04078 Version 1

O2 Sensor Bracket Rattle

Year	Model	Trim	VIN Range
2016	HR-V	2WD only	ALL

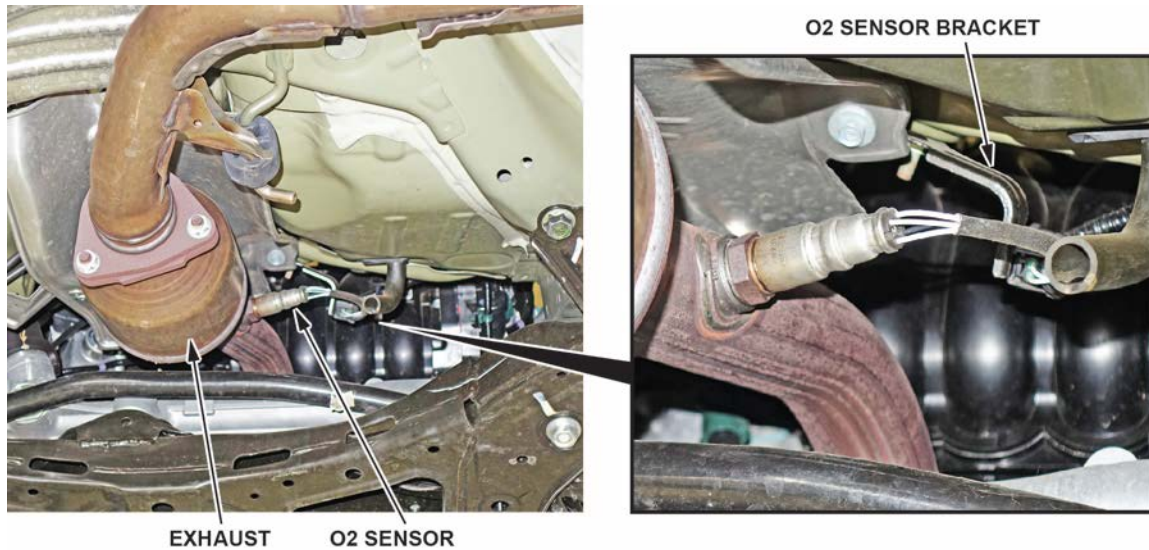
The O2 sensor bracket may not have the correct bend, allowing the harness to rattle.

2. Inspect the bracket.

- If the bracket has a slight bend as shown, the bracket is good. Continue with normal troubleshooting.
- If the bracket has no bend, replace the bracket.

Replace the O2 sensor bracket.

3. Install the new bracket and torque the nut to **9.4 N·m (6.9 lb-ft)**, Then install the harness to the bracket.
